PROPOSED RESIDENTIAL
DEVELOPMENT AT TKOTL 70RP,
PHASE 11. LOHAS PARK, TSEUNG
KWAN O. N.T.

Factory Inspection Report 19

Report Reference: 60646872-FI-R-19

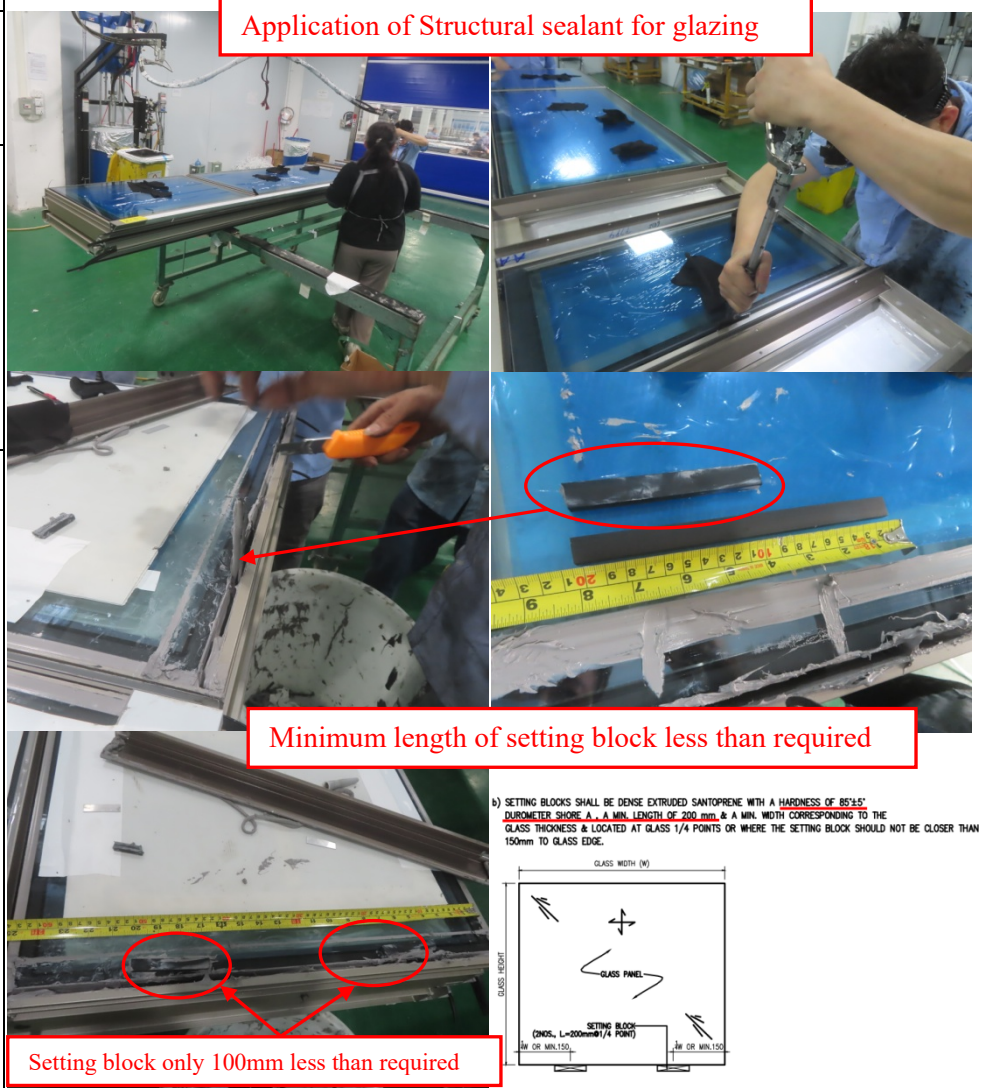
Description:
Application of structural sealant for T3 18-21/F Zone M10, T3 17-21/F Zone M011

Action:
- MIDI is reminded to carry out the remedial works prior products delivery and to improve workmanship for future works

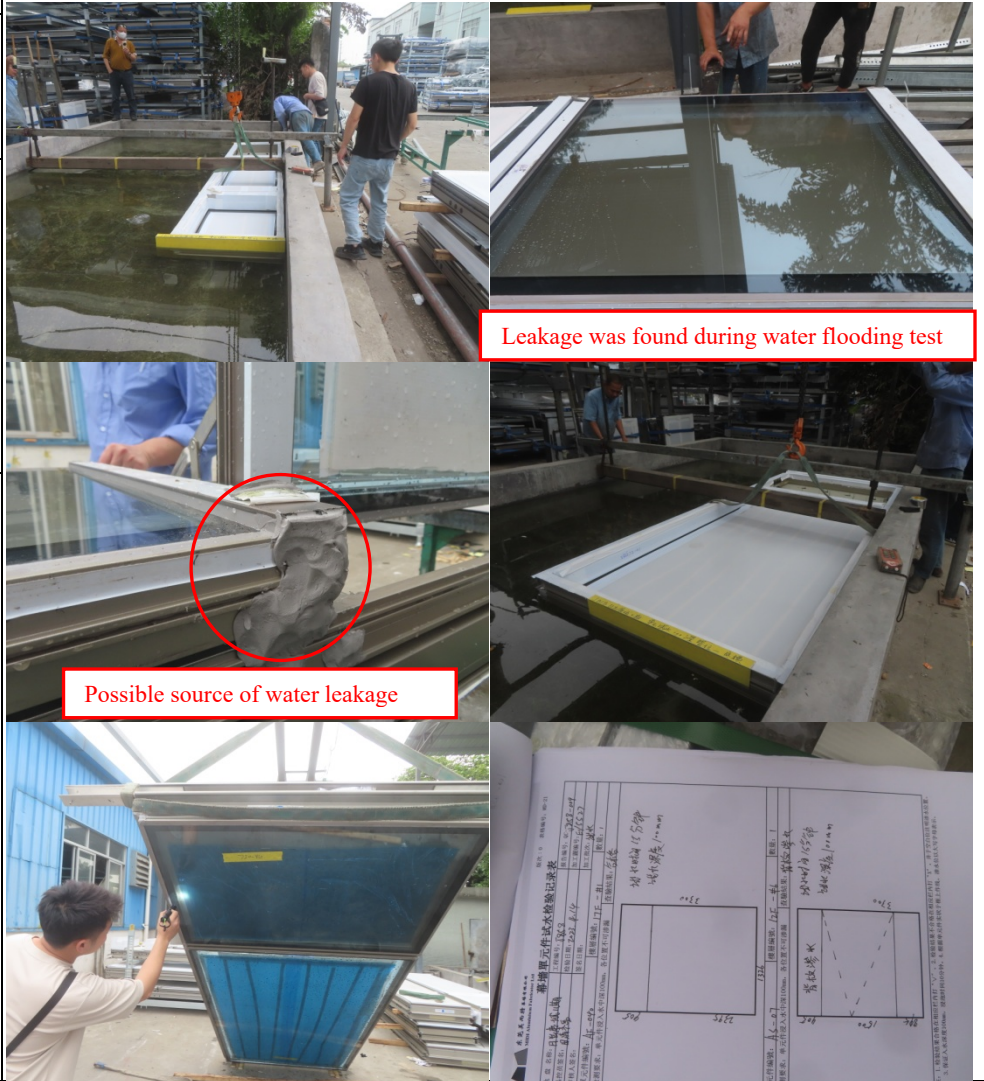
Description:
Water test of 2 numbers unitized panel.
Water leakage was found during flooding test for panel number 12/F_T3B-CW4_AS-07

Action:
- MIDI is required to carry out their internal QA/QC method to improve workmanship for future works

28	Water leakage was found during flooding test for panel number 12/F_T3B-CW4_AS-07 	MIDI is required to carry out their internal QA/QC method to improve workmanship for future works	Report-R-23 Photo 11	The reason for the seepage is that the bottom cavity is not blocked properly, Repair and test - OK		Completed
29	• Insufficient wooden block for protection of gasket was found during factory inspection 	• MIDI is reminded to carry out the remedial works prior products delivery and to improve workmanship for future works	Report-R-23 Photo 13	Final inspection on 28-Apr-2023, No adverse comment		Routine Monitoring
30	• Glue workshop is not a closed space was found during factory inspection, resulting in more dust and high temperature. 	• MIDI is reminded to carry out the remedial works prior products delivery and to improve workmanship for future works	Report-R-26 Photo 8	Reminder only, Added Isolation membranes.		Routine Monitoring
